Access Compliance Report

Public Rights-of-Way

Intersection ID: 16763	Main Street: BUCKNELL_AV	Cross Street: HASTINGS_DR	Location: SW
ADA ID: 683ACCC898DD	Ramp Type: PerpDiag	Initial Pass/Fail: Pass	Overall Compliance: No
Severity Score: 10			
Codes/Mitigation Info/Possible Solution		Field Measurements/Component Compliance

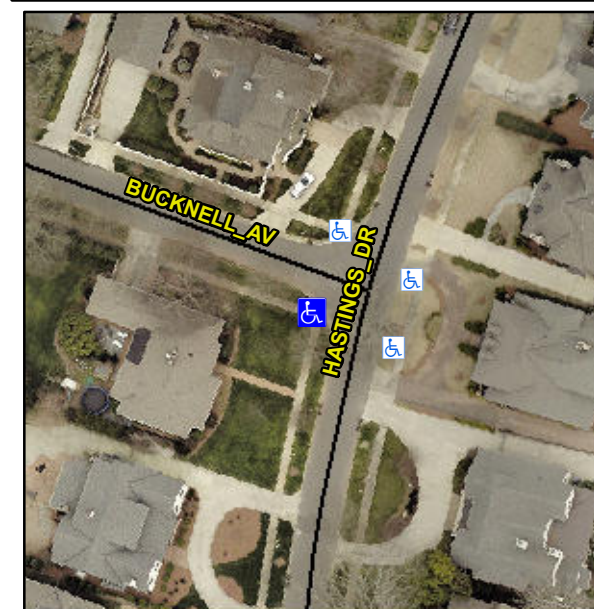
Not Found, R304.2.1, R304.2.2-Perp, R304.3.2-Para, R304.5.3, R305.2

Compliance	Description	Data	Compliance	Description	Data
N/A	Ramp Length (in)	100.0	Yes	Ramp Slope (%)	6.4
Yes	Ramp Width (in)	48.0	Yes	Ramp XSlope (%)	0.4
N/A	Flare Type LT	Sloped	N/A	Flare Type RT	N/A
N/A	Flare Slope LT (%)	0.6	Yes	Flare Slope RT (%)	0.4
N/A	Flare Traversable LT?	Yes	N/A	Flare Traversable RT?	Yes
No	Landing Length (in)	N/A	Yes	DWS Provided?	Yes
No	Landing Width (in)	N/A	Yes	DWS Contrast?	Yes
No	Landing Slope (%)	N/A	Yes	DWS Length (in)	24.0
No	Landing X Slope (%)	N/A	Yes	DWS Full Width?	Yes
N/A	Landing Curb? (Y/N)	No	No	DWS Offset (in)	5.0
N/A	Shared Landing?	N/A			
Yes	Gutter Ponding?	No	Yes	Gutter Slope (%)	0.1
Yes	Gutter Lip Ht (in)	0.0	Yes	Gutter X Slope (%)	0.2
N/A	Painted X Walk1?	No	N/A	Painted X Walk2?	No
	X Walk 1 Direction	To SE		X Walk 2 Direction	To NE
N/A	X Walk 1 Width (in)	N/A	N/A	X Walk 2 Width (in)	N/A
	X Walk 1 Slope (%)	3.1		X Walk 2 Slope (%)	6.3
	X Walk 1 X Slope (%)	2.8		X Walk 2 X Slope (%)	0.6

N/A	Ramp inside XWalk1?	N/A	N/A	Ramp inside XWalk2?	N/A
	Road Slope (%)	0.1	N/A	Clear Space?	Yes
	Road X Slope (%)	6.0	N/A	Clear Space to XWalk (in)	N/A
Yes	Any Obstructions?	No	Yes	Storm Grate/Utility Hazard?	No
	Obstruction Type			Storm Grate/Utility Type	
		N/A			N/A
			Yes	Surface Condition? (G/P)	Good

Remove & Replace Curb Ramp With Two New Directional Ramps or Equivalent.
